Regulatory Docket File

March 15, 1976

Subject: Dresden Station Unit 2
Proposed Amendment to Facility License
No. DPR-19 and Appendix A Technical
Specifications, NRC Dkt. 50-237

PLANAR AVERAGE EXPOSURE (MWD/T)
FIGURE 3.5.1. A

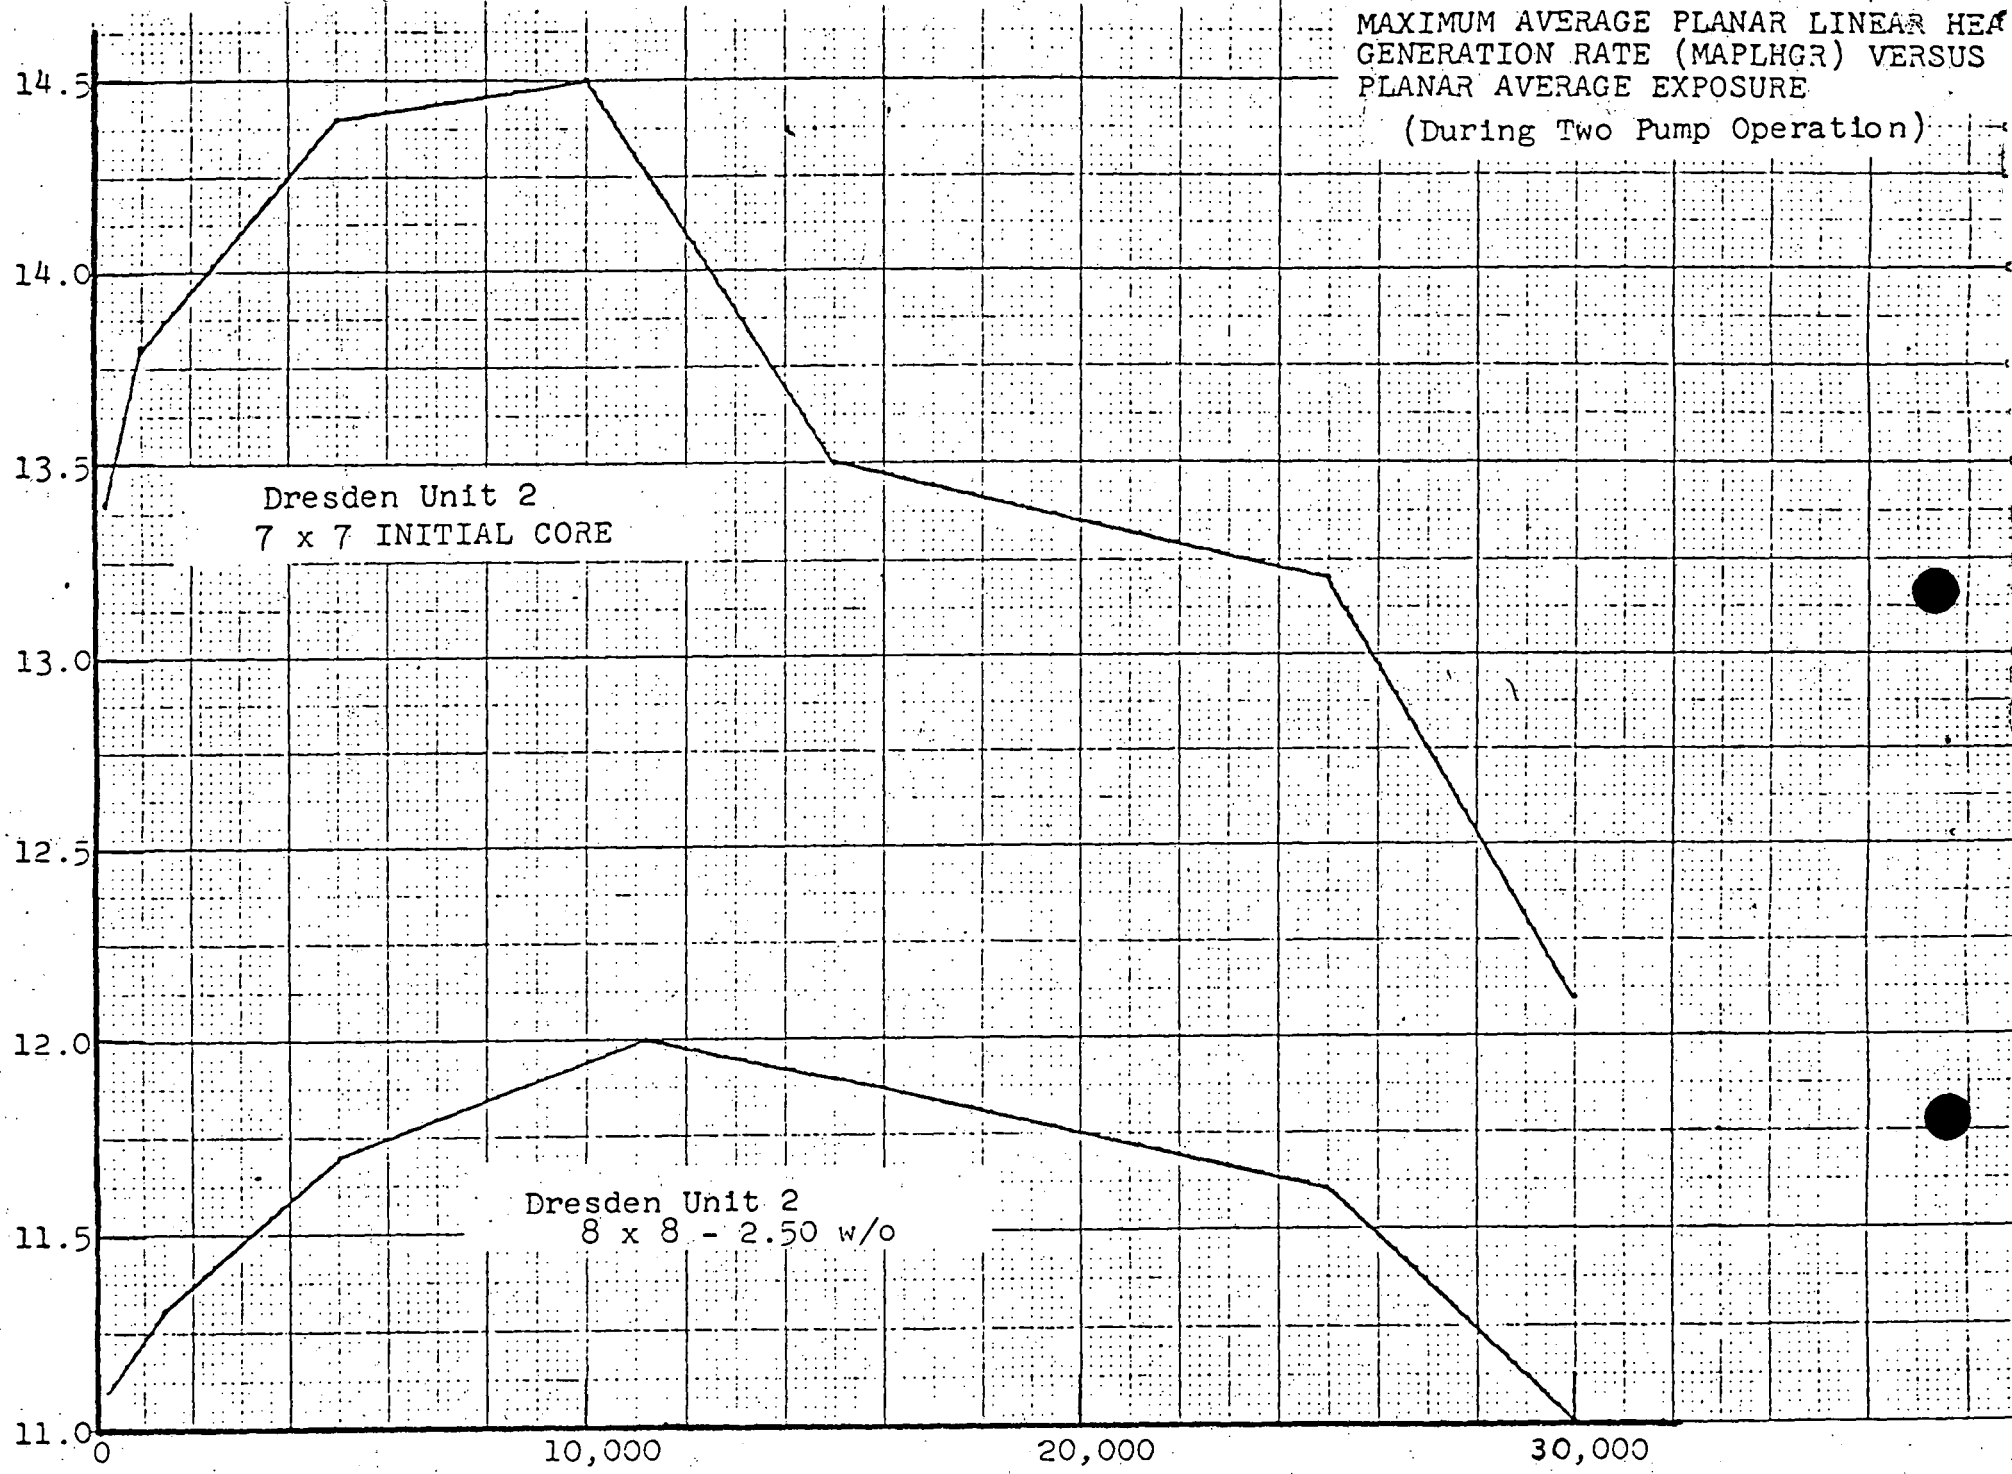
The Technical Specifications change required is the inclusion of the MAPLHGR curve for 8x8, 2.62 w/o fuel which is introduced into the core for the first time. Technical Specification pages 81C and 81C-1 include not only the 8x8, 2.62 w/o MAPLHGR curves, but those for other applicable fuel installed in Dresden Unit 2. These curves are the same as those submitted in Dresden Station Special Report No. 40, Supplement B and are not the same as those presently in the Technical Specifications. Enclosure (1) provides the technical support

During steady state power operation, the average linear heat generation rate (LHGR) of all the rods in any fuel assembly, as a function of average planar exposure, at any axial location, shall not exceed the maximum average planar LHGR shown in Figures 3.5.1-A or 3.5.1-B dependent on fuel type.
